**Proposed Temporary Private Vehicle Park for a Period of 3 Years and Filling of Land in “Village Type Development” Zone, Lot 741 (Part) in D.D. 111, Pat Heung, Yuen Long, N.T.**

## Responses to Comments for Drainage Services Department

**Subject:** Re: Planning Application No. A/YL-PH/1069 - Departmental  
Comments

Responses to Comments for Drainage Services Department  
Planning Application No. TPB/A/YL-PH/1069

## 2. Catchment Area

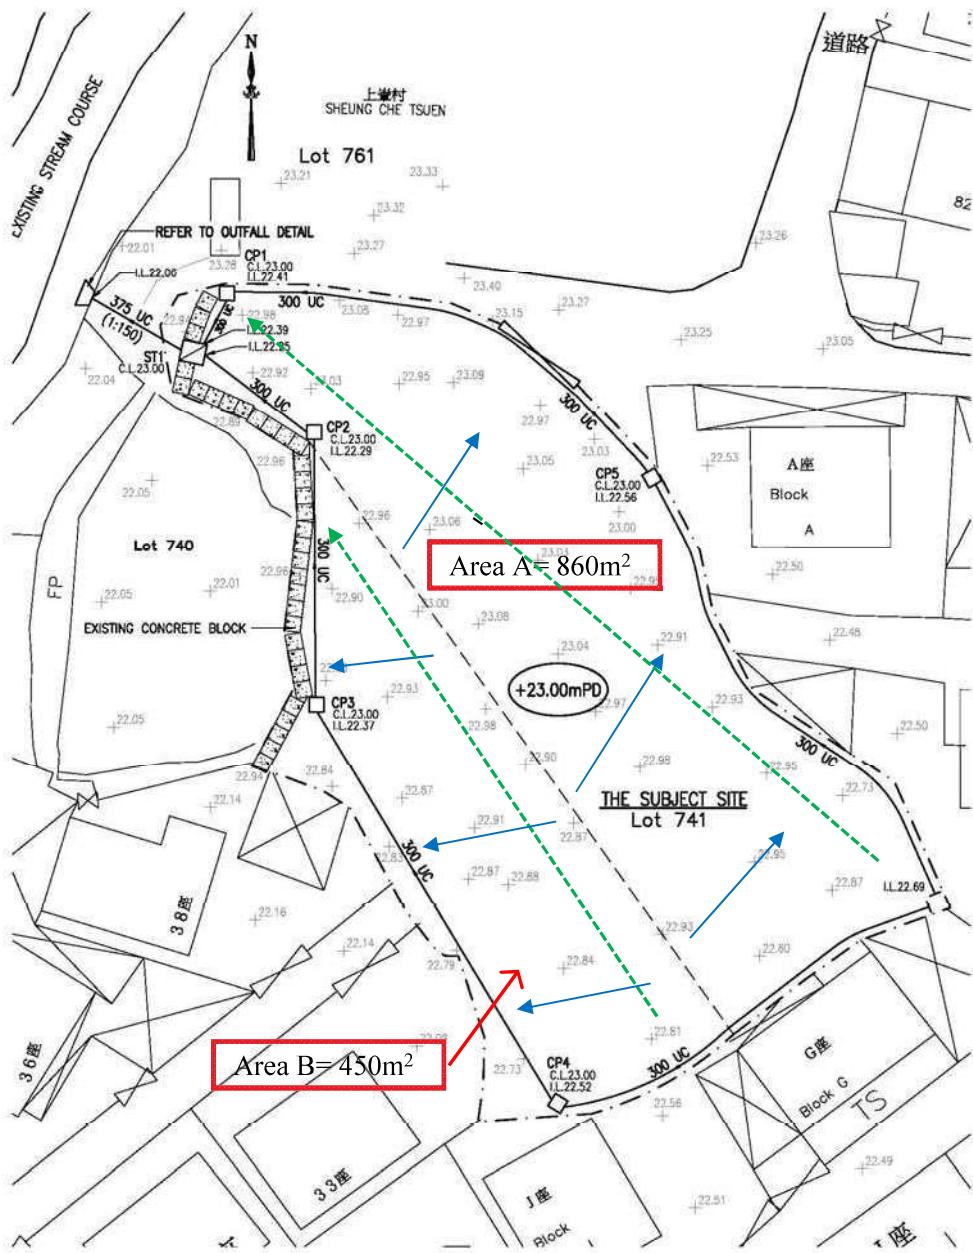
(b) 300 UC with gradient of 1:200 are proposed by the applicant. Please demonstrate with hydraulic calculation that the proposed drainage facilities are adequate to collect, convey and discharge the surface runoff accrued on the application site and to the overland flow intercepted from the adjacent lands. Please also indicate the gradient of the proposed 375 UC and showing its C.L. and I.L. at outfall detail.	See attachment

3. Checking requirement width by rainwater through between CP5 to ST1

Therefore, used 300mm UC is adequate for catchment area of A.

Therefore, used 375mm UC is adequate for catchment area of the application site.

## PROPOSED DRAINAGE PLAN

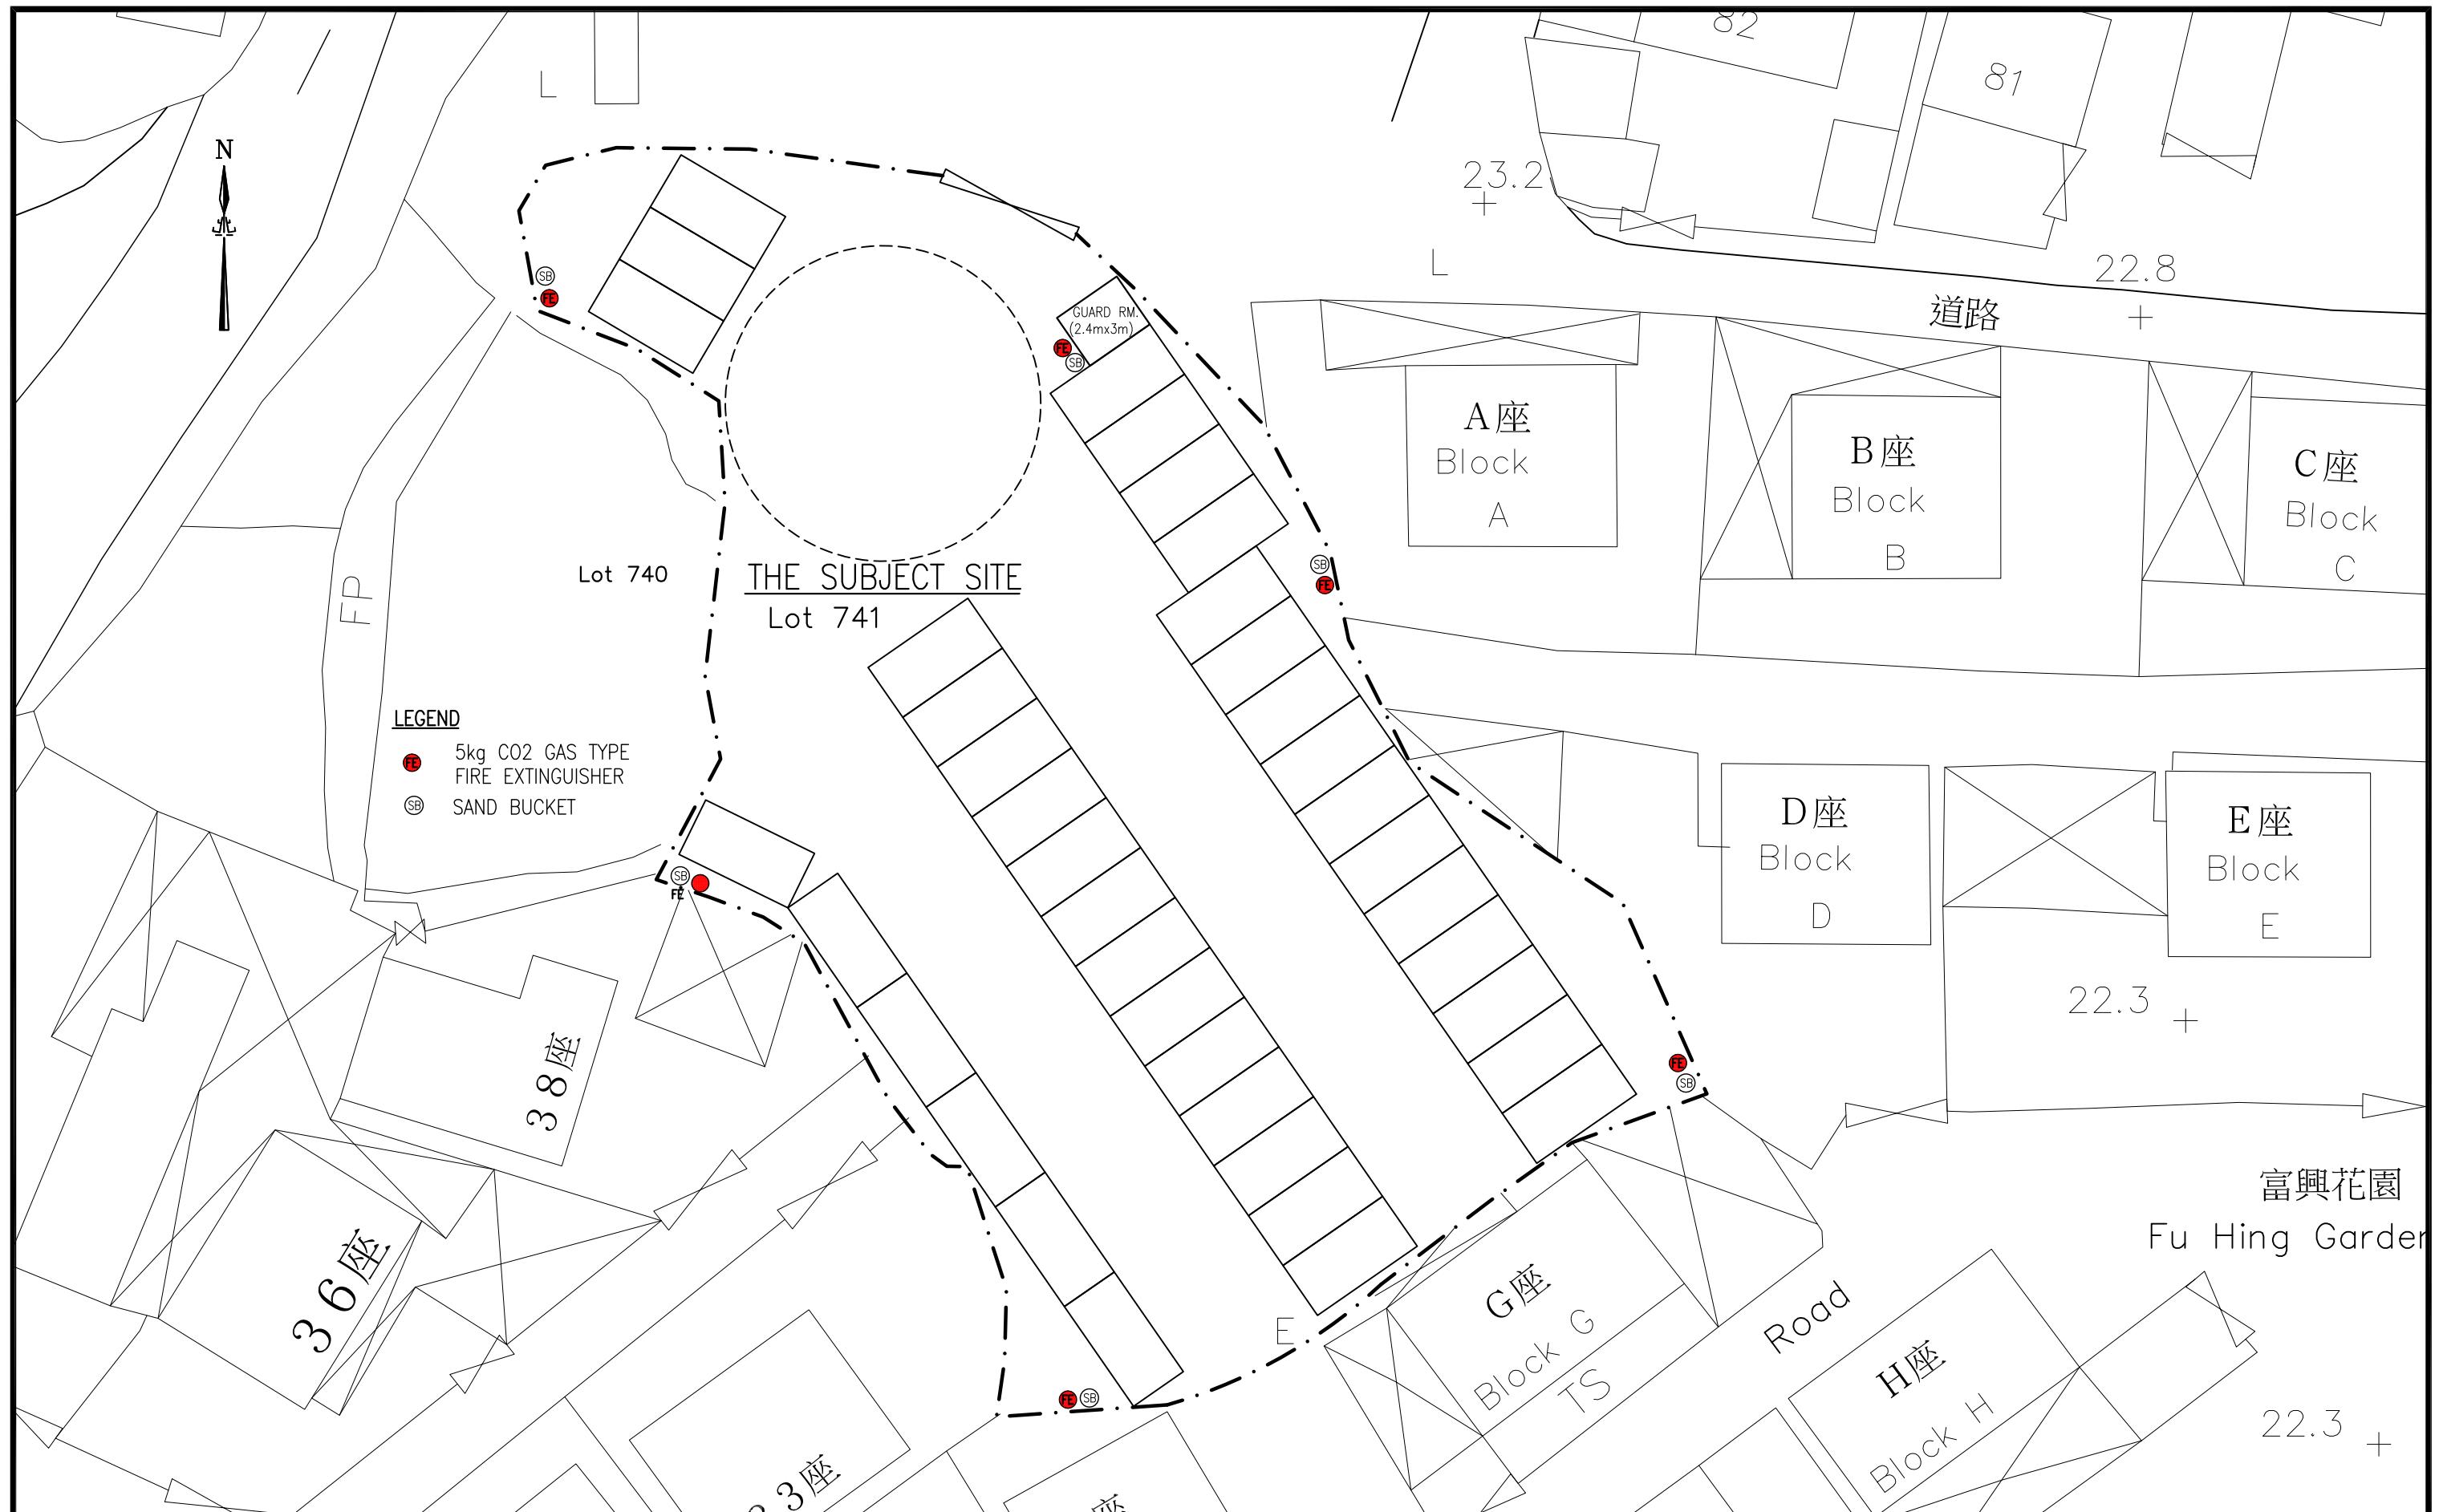
(c) Cross sections showing the existing and proposed ground levels of the captioned site with respect to the adjacent areas should be given.	See attachment

(d) The proposed finished G.L. of the subject site is 22.3 which is about 0.6m higher than the existing G.L. of 21.7. Please demonstrate the proposed site formation works will not affect the overland flow from the adjacent lands.	See attachment

FIRE SERVICE INSTALLATION  
LAYOUT PLAN

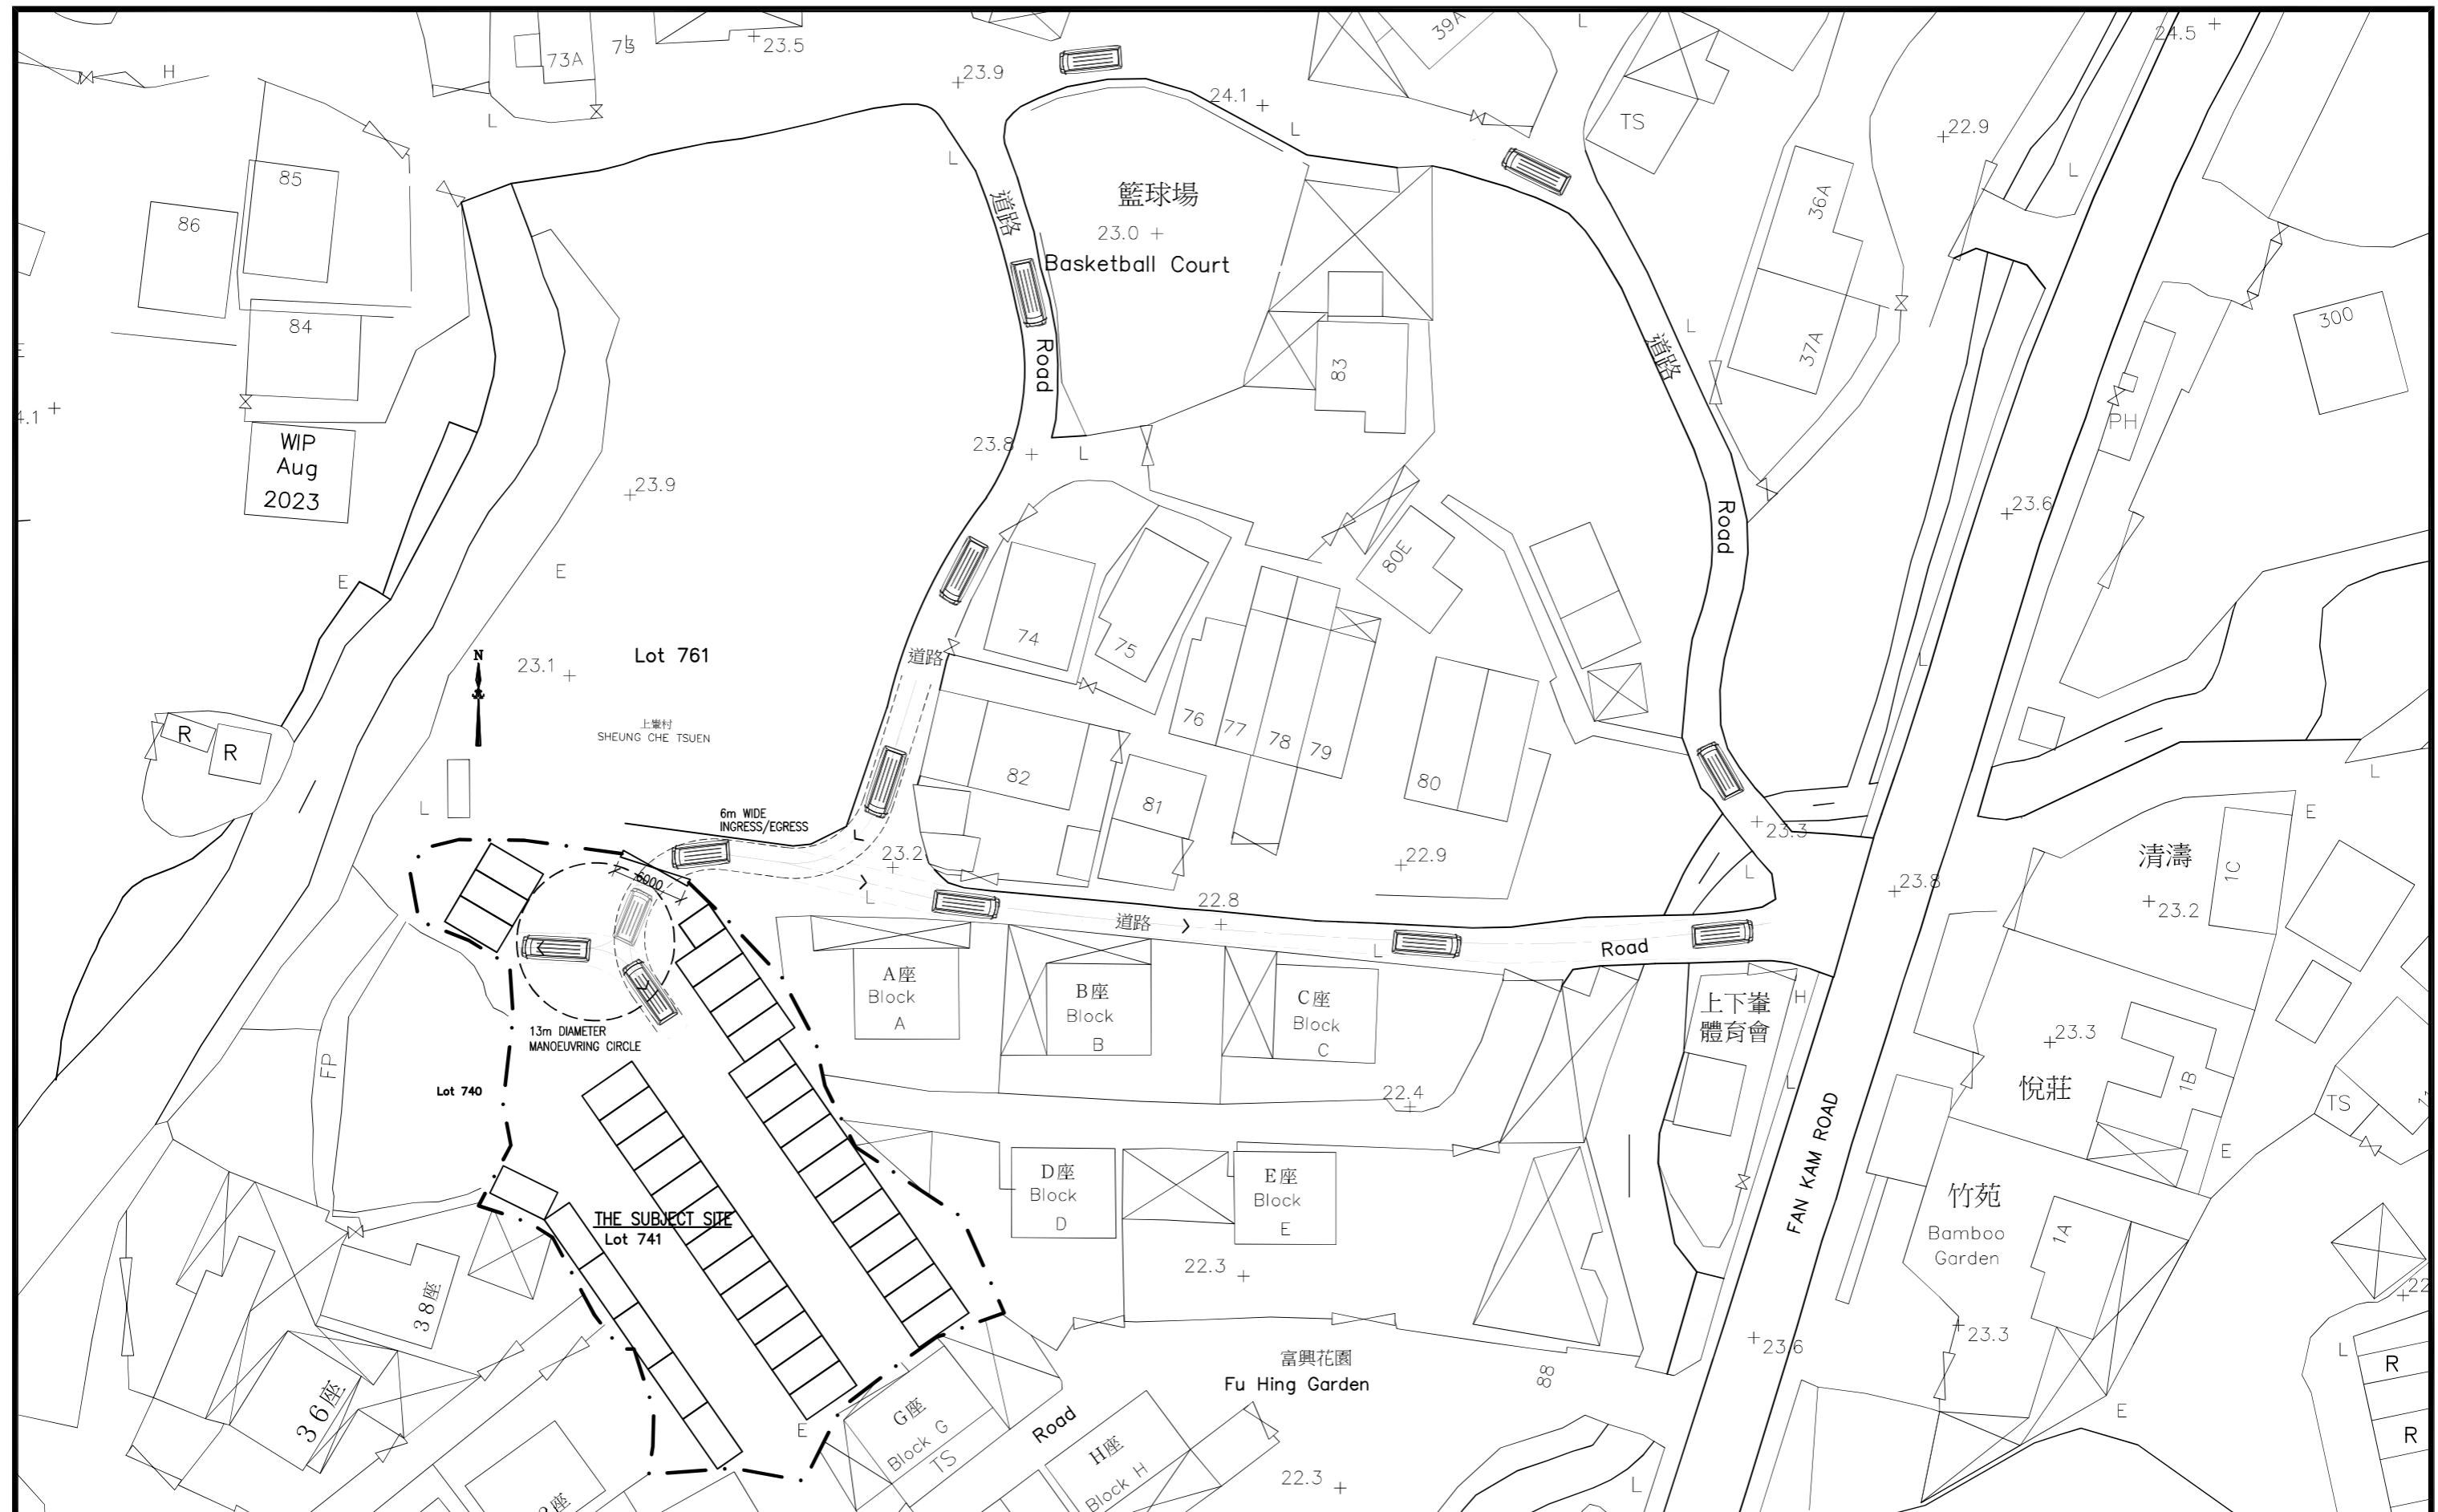
- no specific comment on the application;
- the submitted fire service installations proposal is considered acceptable; and
- as temporary open carpark would pose an acceptable fire risk level with minimal risk in openground environments, provision of fire service installations is not required.
